6.5.2 ASSET MANAGEMENT PROGRAM ADDENDUM – Responses to EPA Follow-on Questions/Comments/Requests

2023 Red Hill Administrative Consent Order: Item 6.5.2 Asset Management Program Addendum

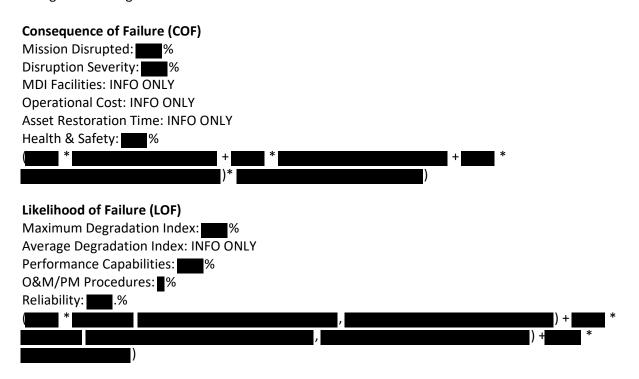
- 4. The Navy's submittal states on p. 4 of the pdf: "In principle, a Risk Assessment is performed annually, which updates risk assessments caused by asset failure to establish maintenance and Sustainment, Restoration & Modernization (SRM) priorities."
 - a. What is the frequency of a risk assessment of JBPHH Water System's assets in practice?
 - b. When was the last risk assessment of JBPHH Water System's assets performed?

- c. The Navy's submittal states on p. 3 that the degradation index is updated at least every 2 years. The DI is a factor in Likelihood of Failure. What parts of a Risk Assessment are reviewed annually?
- d. How is a risk assessment different from a condition assessment?

Response: JBPHH staff conduct a risk assessment annually in the Spring. Results from this risk assessment are used to determine projects that will be submitted for centralized funding (MILCON, special project, ERCIP, etc.) and the priority of projects on the installation's Maintenance Execution Plan (MEP). The last completed risk assessment occurred in March 2023. Another risk assessment for the upcoming project cycles is currently underway.

During the annual risk assessment, staff work to complete all failure scenarios, meaning all fields in the likelihood and consequence of failure tabs are populated. Mitigations are developed for those failure scenarios with a risk score greater than 4.2 (at least, but often are created for those scenarios with lower risk). Often fields were populated in previous years. In this case, engineers review to ensure those fields are up to date. Similarly, there are mitigations (projects) in the database from prior years that will be updated as needed or removed if no longer viable.

Risk assessment is different than a condition assessment in that the risk assessment considers other factors that contribute to the overall impact of an asset/system failing. The risk assessment *includes* condition assessment (DI rating) but goes further to consider mission impact, health and safety, redundancy and several other factors. The risk assessment is conducted every year by engineering staff and management. Condition assessment is conducted routinely by sustainment technicians as they complete works orders (preventive maintenance), when they are advised of an asset's condition (e.g. through USA or other study/report), or if the asset experiences increased breaks (thereby raising the DI).

Per EPA request during the 11/29/2023 meeting, NAVFAC is providing the current URT Risk Formula, Categories & Weights below:

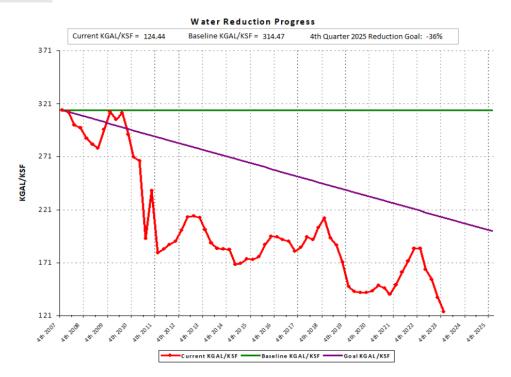
- a. The first 2 metrics listed on p. 5 of the pdf include goals of 100%. What are the targets/goals for the next 3 metrics listed?
- b. What metrics indicate reliability of assets?
- c. Many of the metrics address water quality. Which metrics address water quantity?
- d. Guidance for defining Levels of Service often refer to SMART goals, meaning Specific, Measurable, Attainable, Realistic, and Time Bound. Some of these metrics are not specific, measurable, or time bound.
- e. When was the last time the JBPHH Water System's Asset Management Program was reviewed and updated? The frequency of reviewing and updating this water system's Asset Management Program could be a metric.

Response: Water tank levels, system pressures, pump run times, residual chlorine and fluoride levels are tracked continuously as stated in section 6.5.2.2 Provide Required Sustainable Levels of Service, but the JBPHH PWS does not have a metric on these data points other than to stay within operational parameters required by AWWA and Hawaii State DOH standards. The response was meant to identify what the Navy tracks but there is no metric associated with this data currently. The goal is to stay within operational parameters at all times.

Reliability is factored into the URT Risk Score and is 23.2% of the Likelihood of Failure calculation. Potable Water Branch also tracks water line breaks.

Metrics for water quantity include water reduction goals for overall intensity (KGal/KSF) and irrigation water. The current goal is a 2% reduction in intensity each year from 2007 to 2025. The following graph is a sample showing progress on this metric.
